The Mount Vernon Council of Citizens Associations, Inc.

Subject: Airplane Noise Reduction Efforts--- Approved by the MVCCA General Council Dec. 16, 2020

**MOUNT VERNON COUNCIL OF CITIZENS' ASSOCIATION (MVCCA)
RESOLUTION (TRANS) 2018-1 SUPPORTING THE FULL
IMPLEMENTATION OF THE METROPOLITAN WASHINGTON AIRPORT
AUTHORITY NOISE WORKING GROUP (MWAA WG)
RECOMMENDATION #8 AND RECOMMENDATION #11 FOR REDUCING
THE NOISE IMPACT OF REAGAN NATIONAL AIRPORT DEPARTING AND
ARRIVING FLIGHTS SOUTH OF THE AIRPORT.**

**Reagan National Airport
Community Working Group
Recommendation # 8
(Approved July 27, 2017)**

Figure 1

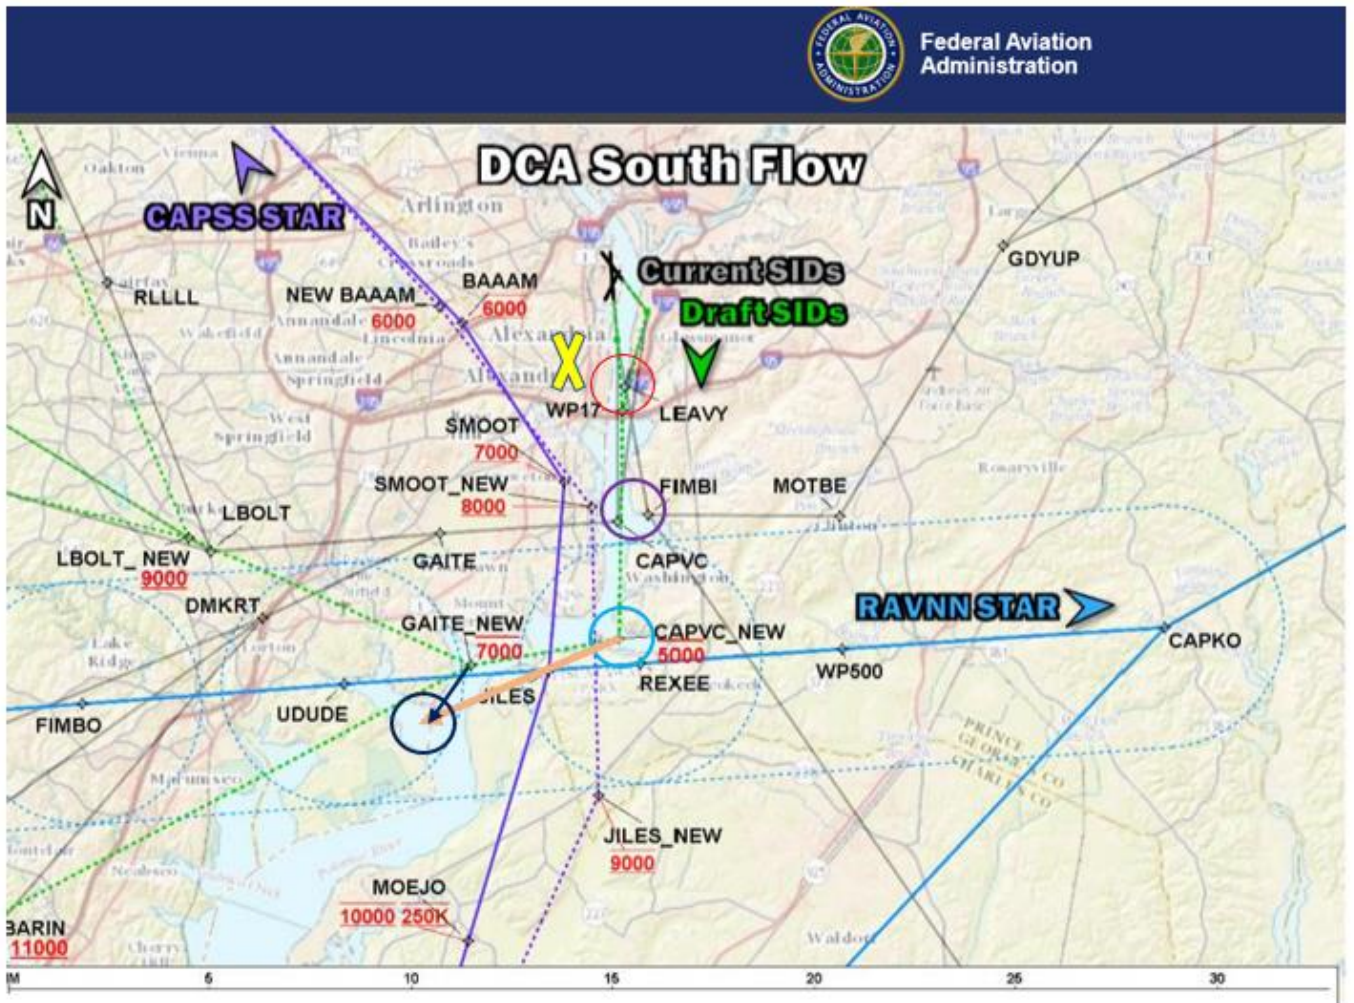
1. Except for turboprop and operational emergencies, eliminate early transition turns to the west over Alexandria City. **See yellow X**
2. Combine Waypoint (WP) 17 and WP Levy and implement 1 WP centered over the Potomac River before crossing the Wilson Bridge. **See red circle on Figure 1**

3. Keep South Flow departures centered over the Potomac River.
4. Move current WP FIMBI west towards the Potomac River closer to where current CAP VC WP is located. Airplanes heading east and northeast will still make east transition turn at FIMBI. **See purple circle on Figure 1.**

6. Move the CAPVC New WP further west over the Potomac River enough to avoid crossing land near Fort Washington. **See light blue circle on Figure 1.** At the CAPVC New WP make a right turn climbing to 7000 ft. or higher towards Gaithe New WP.

7. Move Gaithe New WP further south to a point south of Fort Belvoir, Virginia and north of Mason Neck. **See dark blue circle and arrow on Figure 1.**

Figure 2

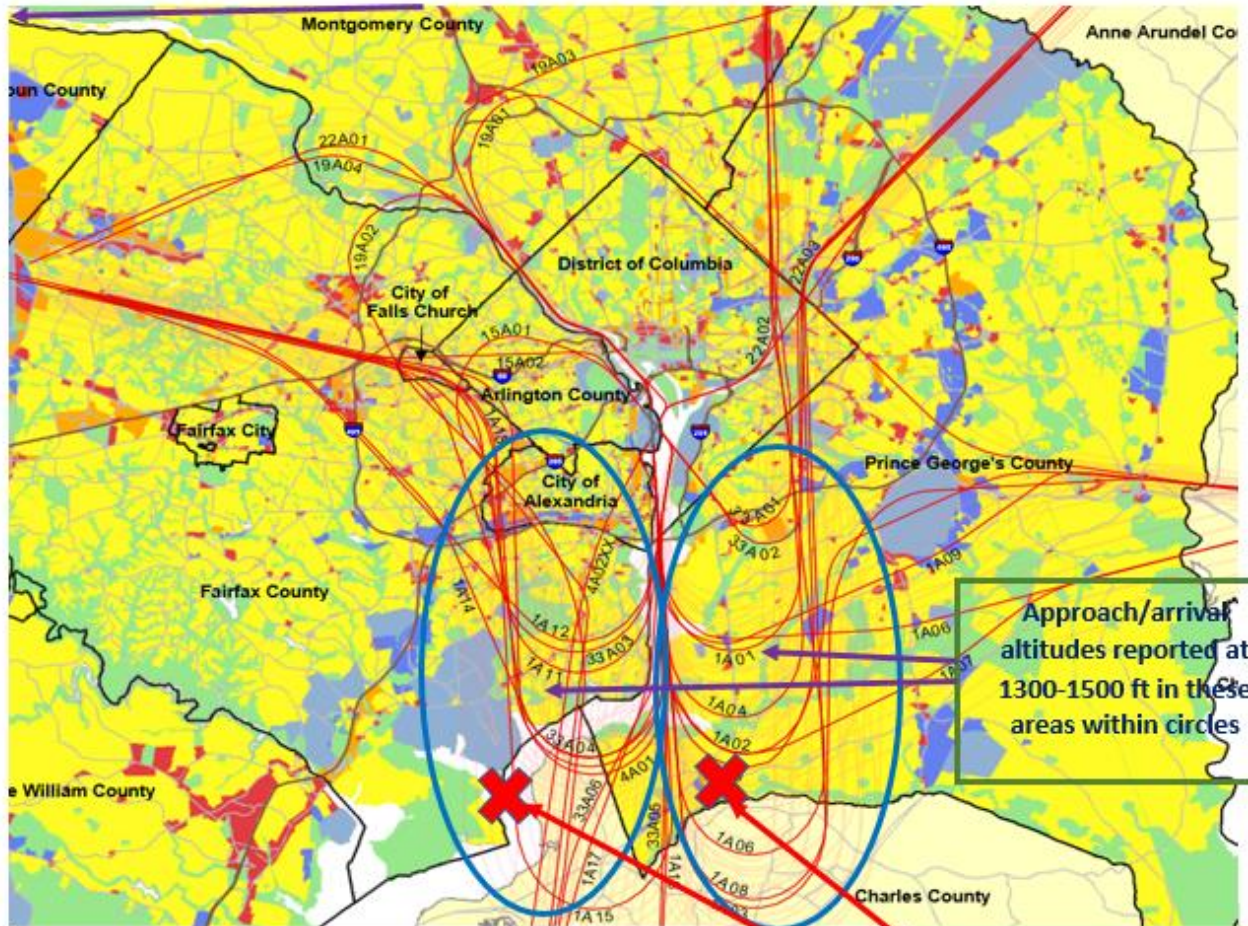
1. The Working Group requests that the FAA review north flow approach procedures and provide alternative approach flight paths and altitudes so that airplanes are not flying over Maryland and Virginia (see figure 2 circles) at altitudes below 2000 ft. Airplanes approaching DCA RWY 1 should not descend until they are established over the center of the Potomac River.
2. One option would be for approach/arrival traffic to arrive at a new arrival WP (Figure 2 Red X's) and mirror the approach via Cap VC New at 5000 and descending over the Potomac River. A similar entry WP could be established for airplanes coming from East/NE crossing Accokeek at 5000 ft. or higher.

Approach/arrival altitudes reported at 1300-1500 ft in these areas within circles

Approach entry WPs for north flow arrivals in VA and MD at 5-7000 ft; enter WP and start descent over Potomac River

Attachment #1: DCA North Flow Arrivals: FAA Response dated November 16, 2017

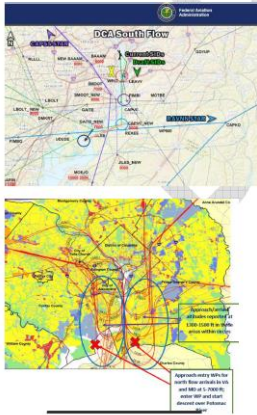
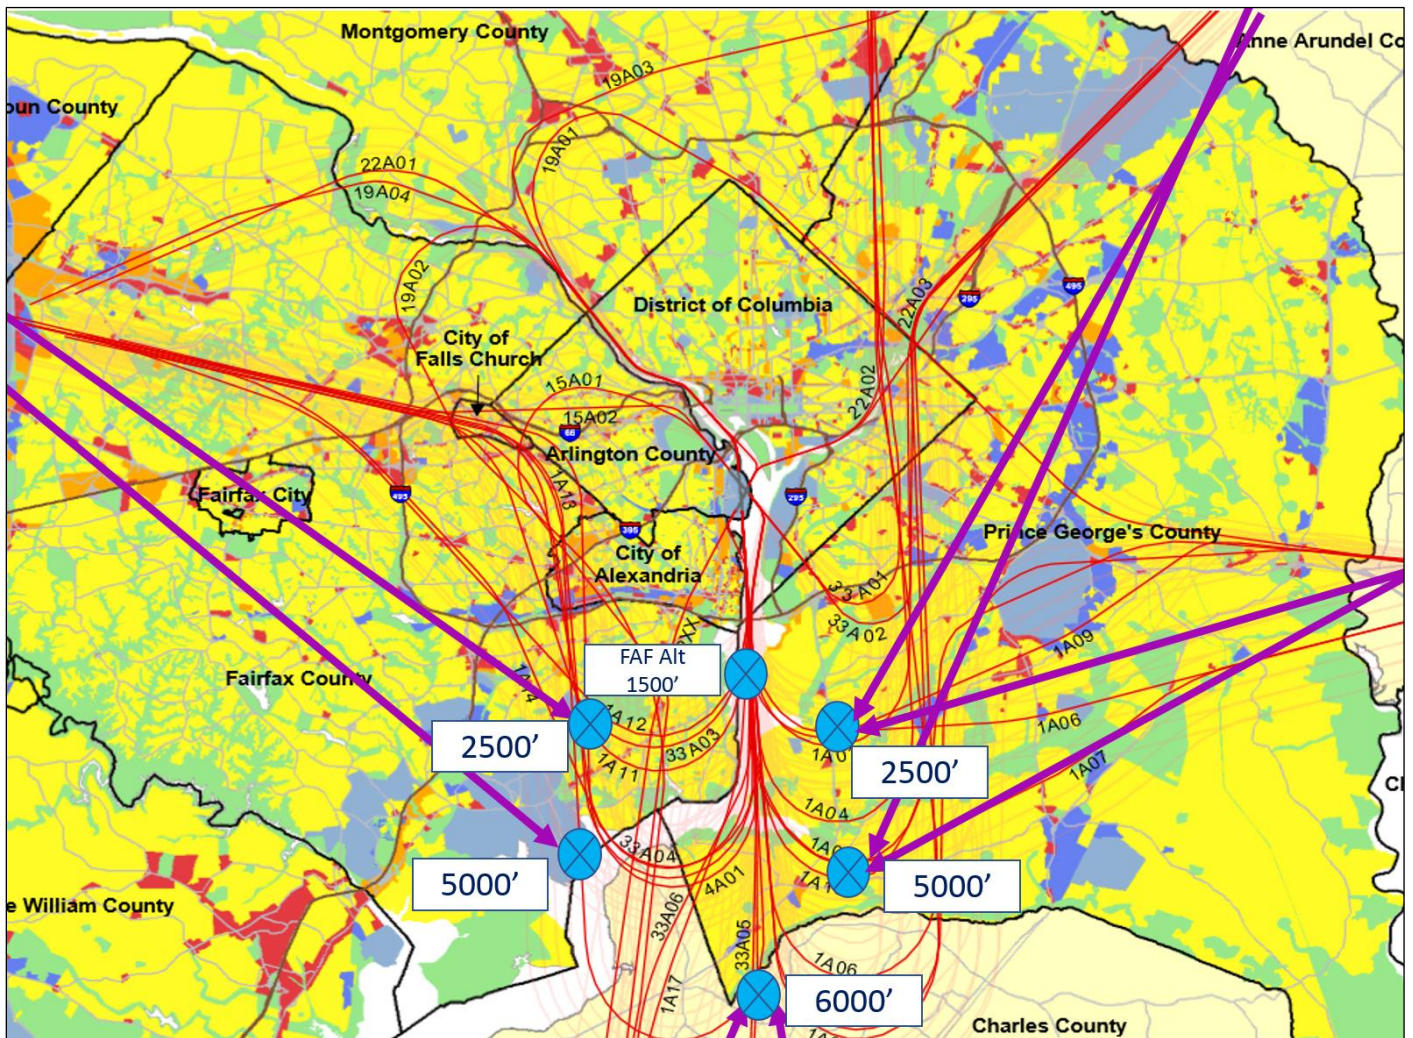
1. The Working Group requests that the FAA review north flow approach procedures and provide alternative approach flight paths and altitudes so that airplanes are not flying over Maryland and Virginia (see figure 2 circles) at altitudes below 2000 ft. Airplanes approaching DCA RWY 1 should not descend until they are established over the center of the Potomac River.
2. One option would be for approach/arrival traffic to arrive at a new arrival WP (Figure 2 Red X's) and mirror the approach via Cap VC New at 5000 and descending over the Potomac River. A similar entry WP could be established for airplanes coming from East/NE crossing Accokeek at 5000 ft. or higher.

1. We reviewed the statement that arrivals were between 1300 to 2000 ft. over Mt. Vernon and Accokeek and found that the overwhelming majority of the aircraft were actually at 1700 ft. and above until over the river. The track data used was from traffic analysis from Sept 1 – Oct 31, 2017 provided to us by ATAC. The track data was filtered starting at 1300 ft. to 2000 ft. and 100 ft. increments were removed from the upper limits of the filter on each successive slide to gain a better understanding of the volume of tracks by altitude. Data analysis concluded that there is no need to recommend operational changes at this time.

2. We isolated West arrival tracks from Sept 1 – Oct 31, 2017 resulting in a total of 6,411 arrivals. We then isolated West arrival tracks that based north of KATRN resulting in a total of 1801 arrivals. That is 28 % of total arrivals from the west. Data analysis recommends that there is no need for operational changes at this time.
